Appln No. 09/955,693

Reply to Office action of December 10, 2004

Amendments to the Drawings:

Figure 1

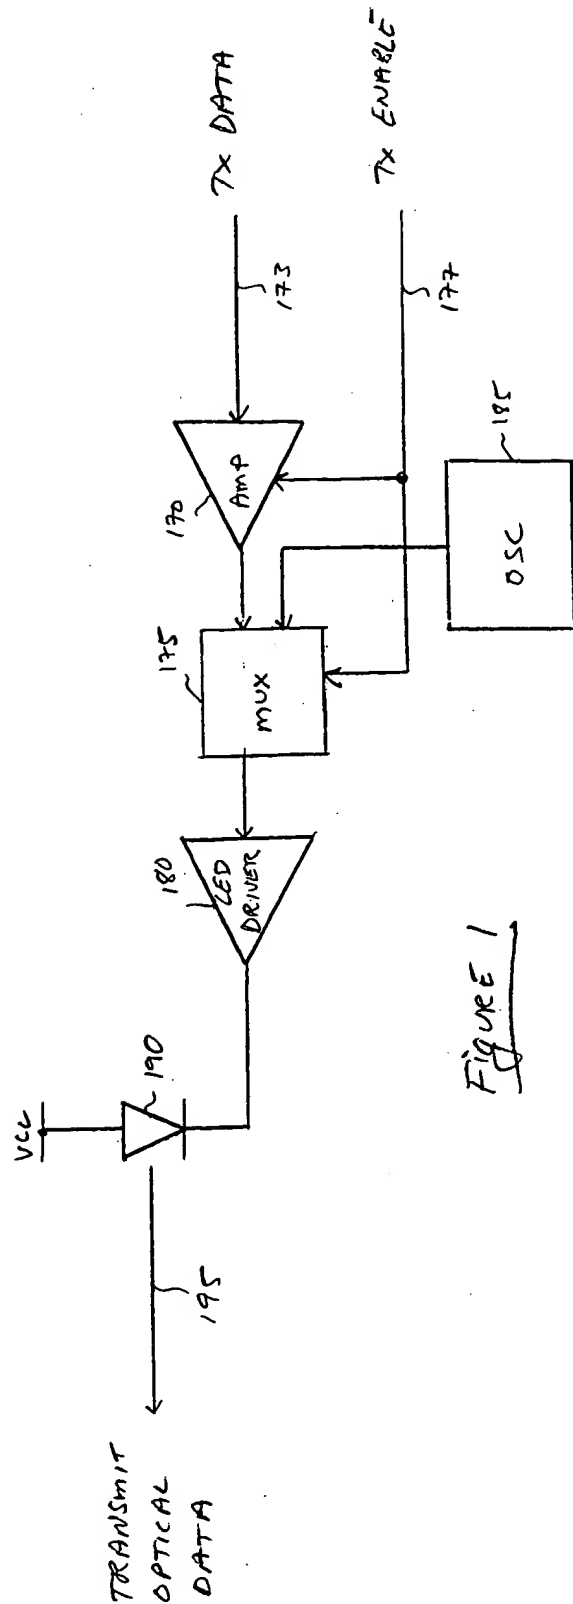
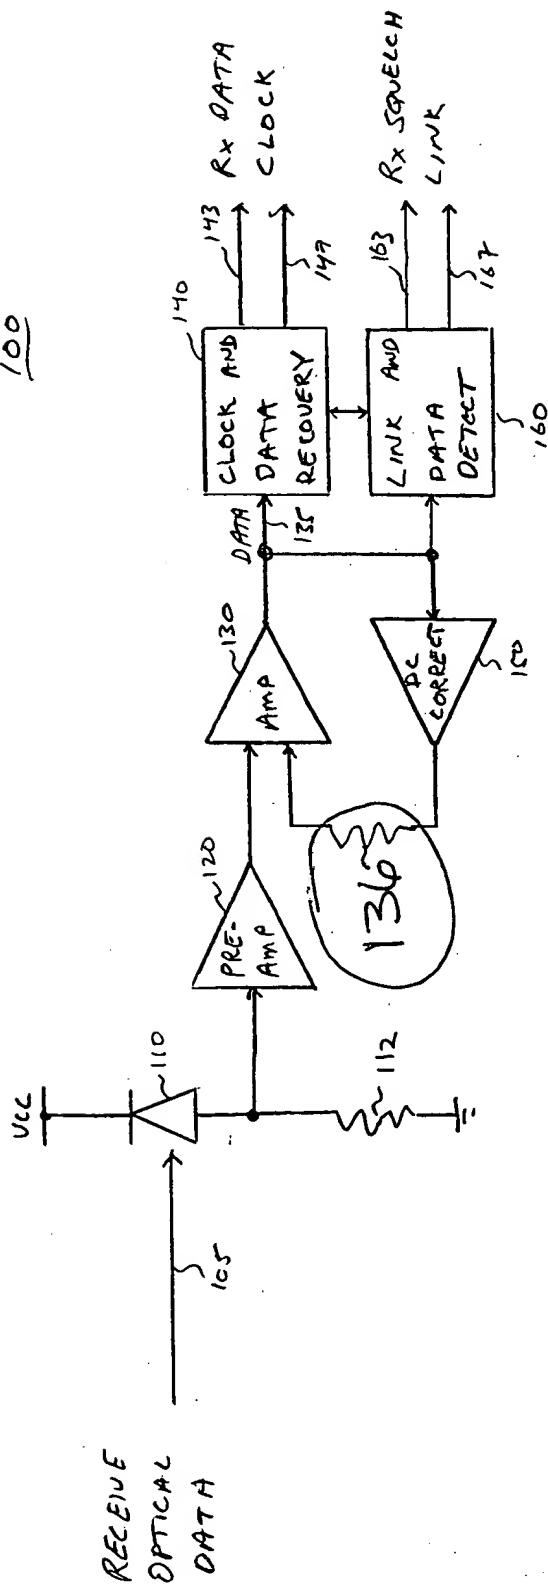
Figures 1, 4A, 5, 6, and 13 are objected to for labeling errors. These figures have been amended to address the objections and correct the errors.

The attached sheets of drawings include changes to Figures 1, 4A, 5, 6, and 13 of this Application. These sheets, which include Figures 1, 4A, 5, 6, and 13 replace the original sheets including Figures 1, 4A, 5, 6 and 13.
